Requested Incidental Take Permit for Crotch's Bumble Bee (Canyon Hills Project)

Final Supplemental Environmental Impact Report

City of Los Angeles Case No. ENV-2002-2481-EIR
State Clearinghouse No. 2002091018

February 2026

Figure 1. Santa Monica Mountains Conservancy map showing the proposed Canyon Hills Project and surrounding habitat and connectivity impacts. Also present in Exhibit 3.

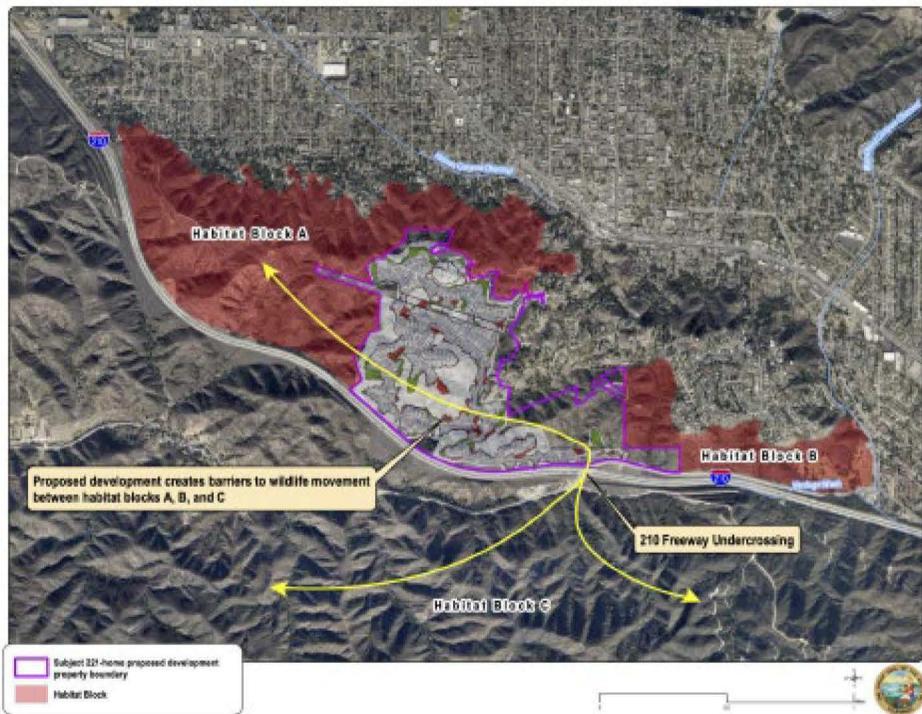
As shown in a map prepared by the Santa Monica Mountains Conservancy (Figure 1), the proposed Project would sit right between two intact habitat blocks north of the 210 Freeway (Habitat Block A and B), removing valuable habitat in the limited remaining open space north of the 210 Freeway and completely isolating the remaining habitat blocks from one another, severely impairing habitat connectivity. The Project would also severely impede the efficacy of

the 210 Freeway undercrossing, as the proposed Project lies directly adjacent to the crossing on the north side of the freeway. This undercrossing currently connects Habitat Blocks A and B with the larger Habitat Block C south of the 210, and the impairment of this crossing that would result from the proposed Project and its associated edge effects would likely sever connectivity between intact and high-quality habitats north and south of the 210 Freeway.

Regarding mountain lion movement, refer to Topical Response No. 1 (Scope of the Draft Supplemental EIR). See also Section 3.5 of the Draft Supplemental EIR explaining why its analysis focuses on the Approved Project's impact on CBB.

Figure 2. Proposed Wildlife Movement Path for the Canyon Hills Project.

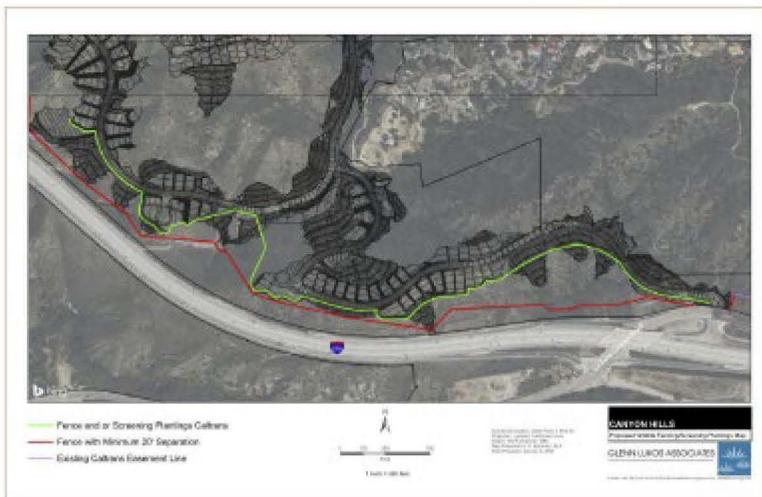
The Project proponent has argued that these changes will not significantly impede connectivity, which is clearly false. We have reviewed the one-page document entitled “Wildlife Movement Path” that appears to have been prepared by the developer’s consultant, and it is woefully deficient as a basis for analyzing or mitigating impacts to mountain lions and wildlife connectivity (Figure 2). Indeed, the “movement path” outlined in the document appears designed to funnel animals into narrow areas next to the 210 Freeway with no pathway for actual wildlife movement. Mountain lions are very sensitive to human activities, noise, and light (as documented above), all of which would be abundant along the 210 Freeway as well as along the edges of the proposed development. The plan presented in the “Wildlife Movement Path” is clearly not an appropriate or workable pathway for wildlife movement. The proposed Project will thus interfere with both local and regional connectivity, further fragmenting the limited habitat that remains available to the struggling local mountain lion population.

The DSEIR thus fails to establish a proper baseline, ignores an enormous amount of new information that has emerged since the FEIR's initial certification in 2005, supplies an inaccurate and insufficient analysis, and thereby fails to adequately analyze and mitigate direct and indirect significant impacts to mountain lion and mountain lion movement that are likely to occur from the proposed Project, in violation of CEQA.
